TO: Jerry Davidson, Goode Perception Design Group
FROM: Elizabeth Steward, Associate Planner- Development Review
DATE: 7/21/26
SUBJECT: Parker Pointe F1 AMD 1 L3A - Huntington Bank

LOT 3A PARKER POINTE SUBDIVISION FILING NO. 1, AMENDMENT NO. 1

HUNTINGTON NATIONAL BANK

SITE PLAN
3 OF 10

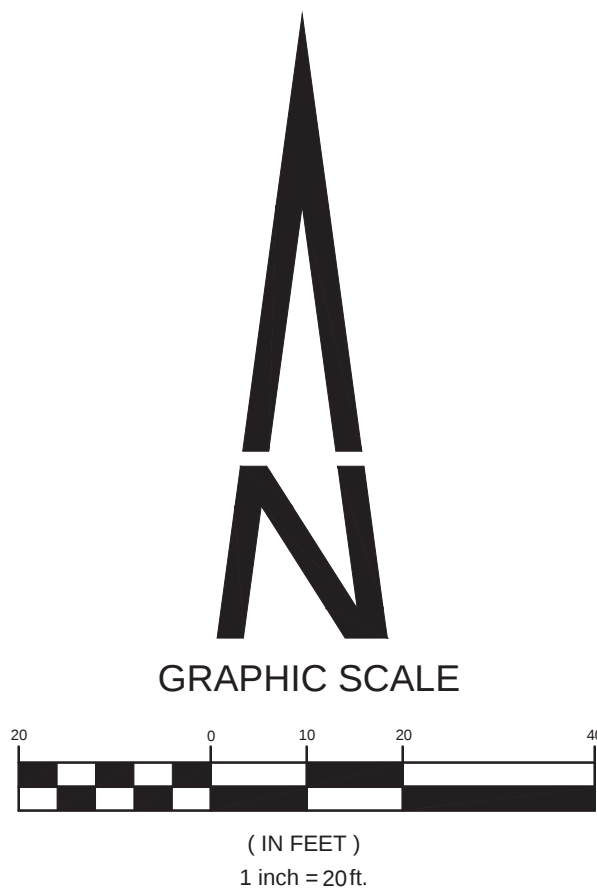
2. **The Colorado Electric Ready Plan was adopted by the building department on July 1, 2026. Part of this is the requirement of EV Chargers for Commercial Projects. If you would like to proceed with this Site Plan without EV Chargers we can, but please note it will require a Site Plan Adjustment/Amendment during the Building Permit Stage to add them in and may affect the electric capacity of your transformer with CORE. For additional information on this requirement and its effects, please reach out to your reviewers from Building and CORE Electric.**

The Colorado Electric Ready Plan was adopted by the building department on July 1, 2026. Part of this is the requirement of EV Chargers for Commercial Projects. If you would like to proceed with this Site Plan without EV Chargers we can, but please note it will require a Site Plan Adjustment/Amendment during the Building Permit Stage to add them in and may affect the electric capacity of your transformer with CORE. For additional information on this requirement and its effects, please reach out to your reviewers from Building and CORE Electric.

LANDSCAPE PLAN

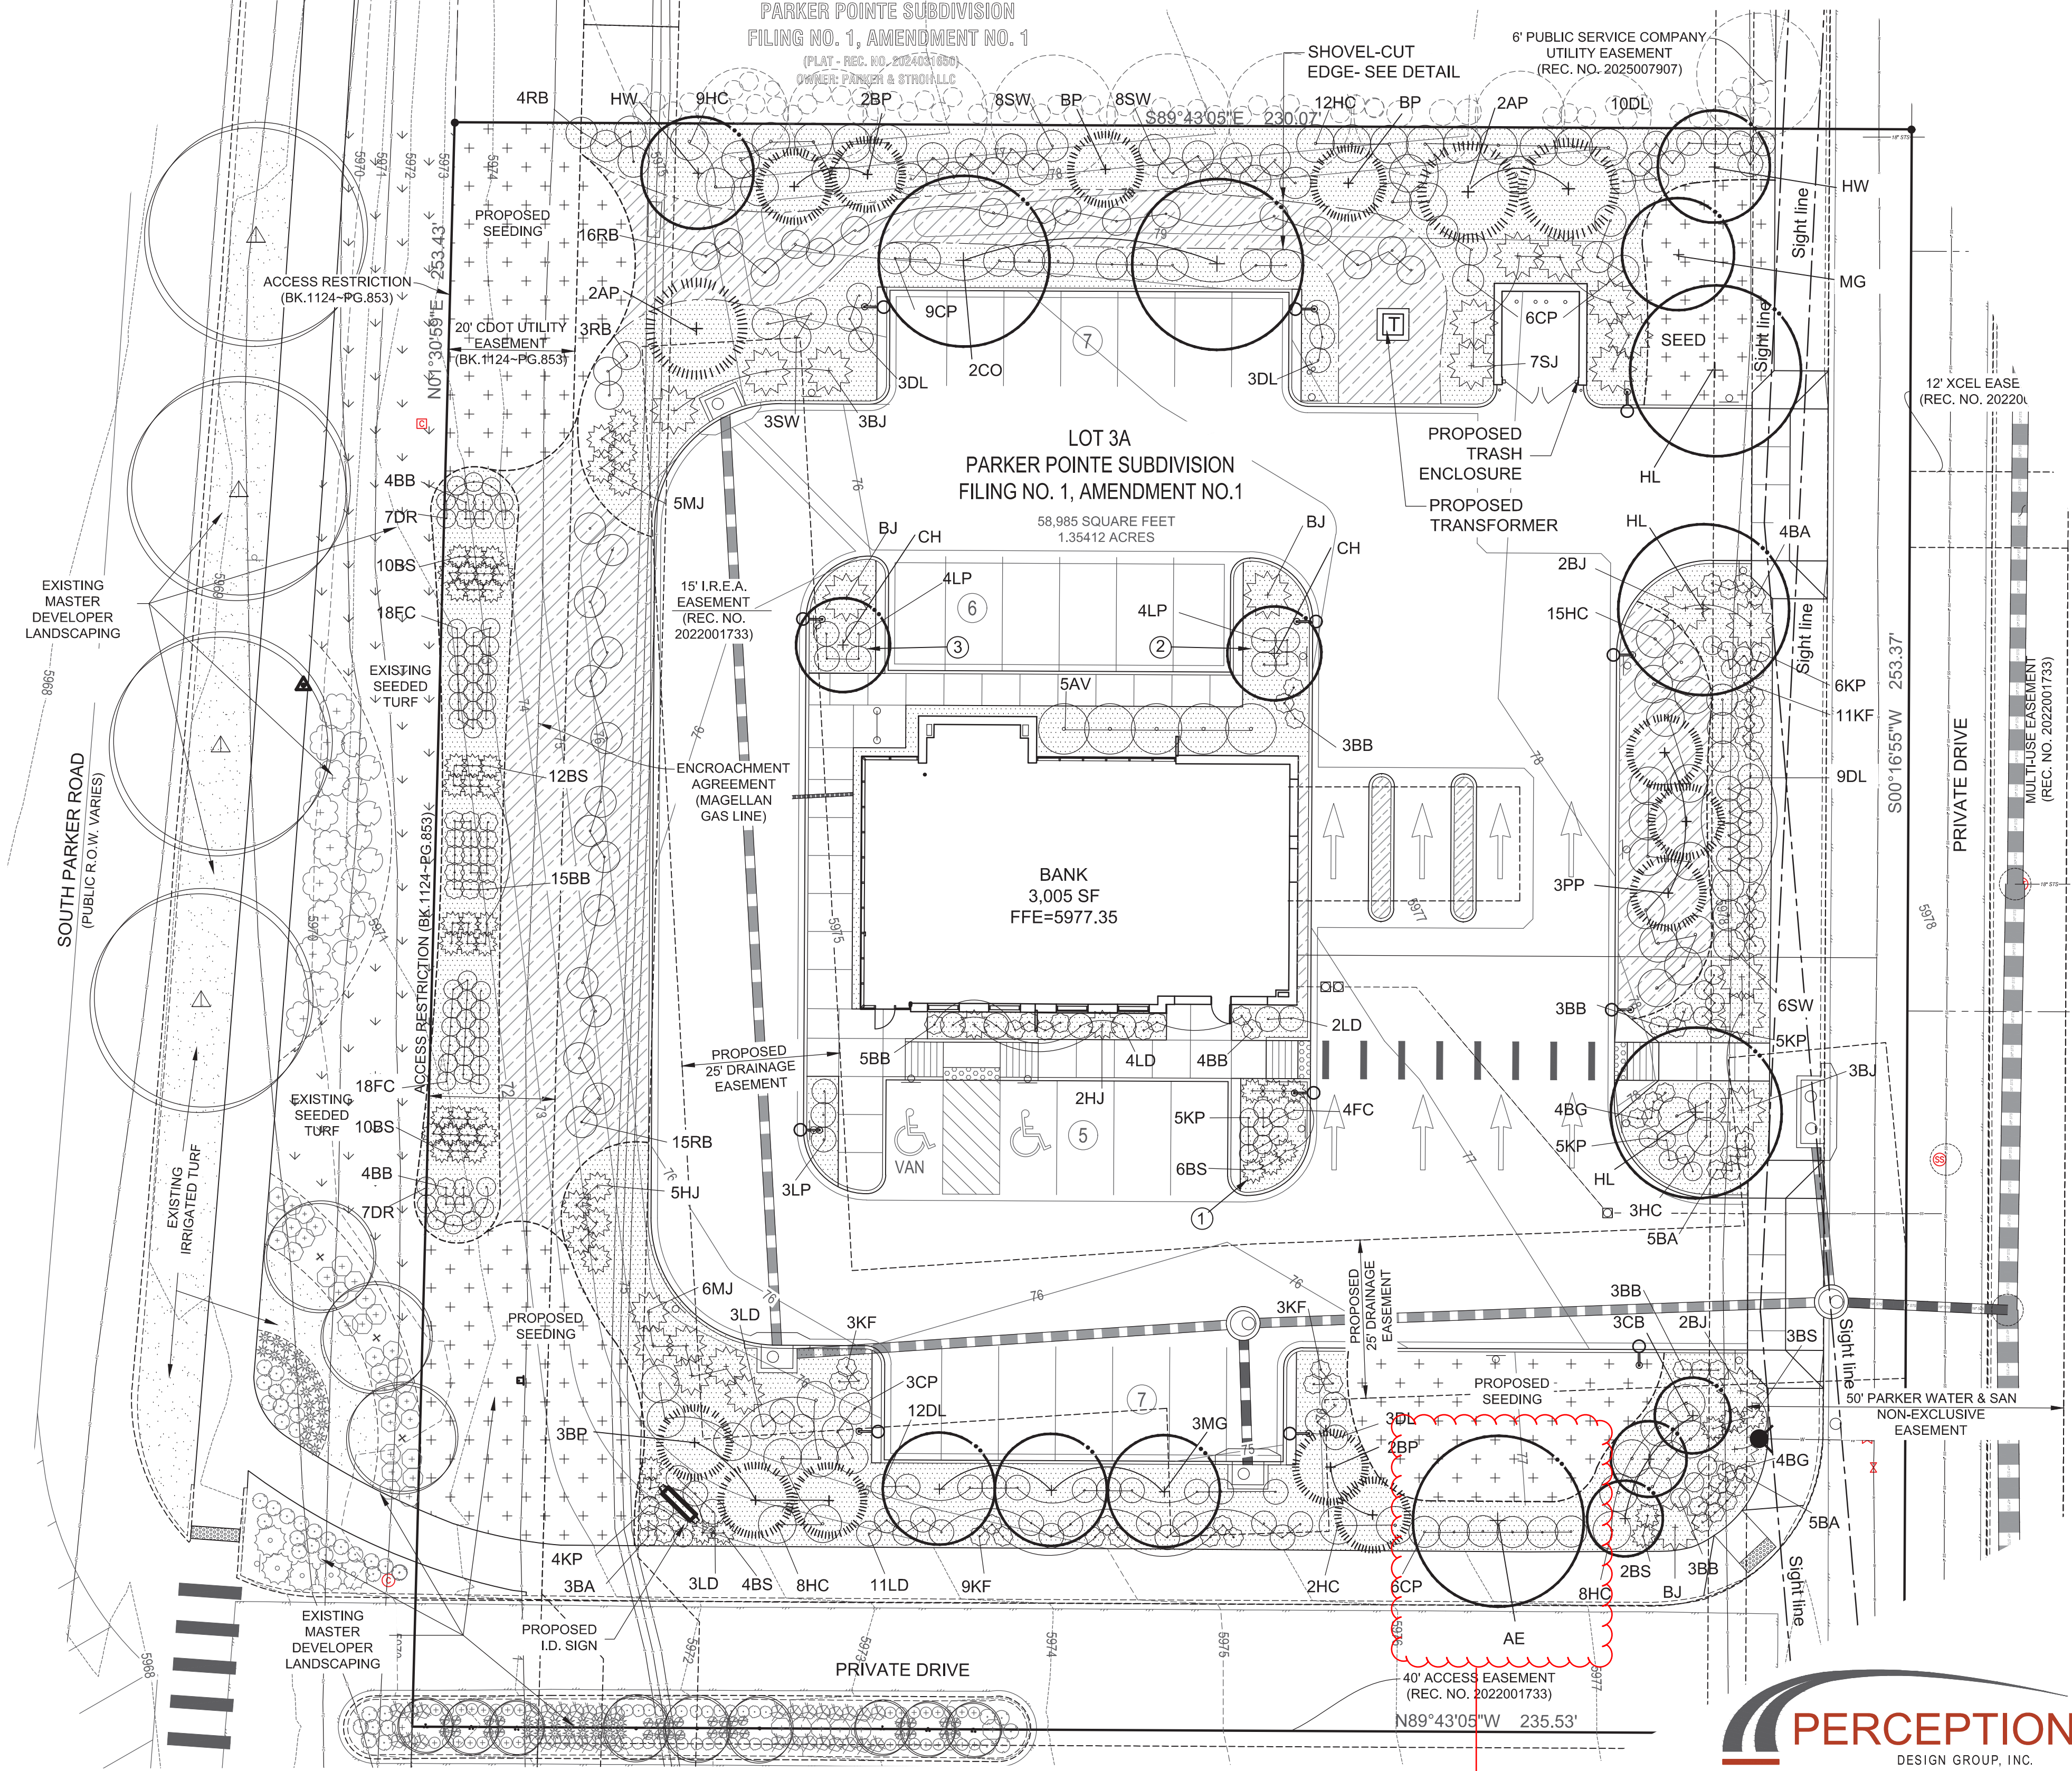
1. **Please switch the species below the drive lanes along the private drive from deciduous to evergreen plants to provide year round screening.**

Please switch the plantings
here for Evergreens to provide
year round screening for the
drive thru lanes
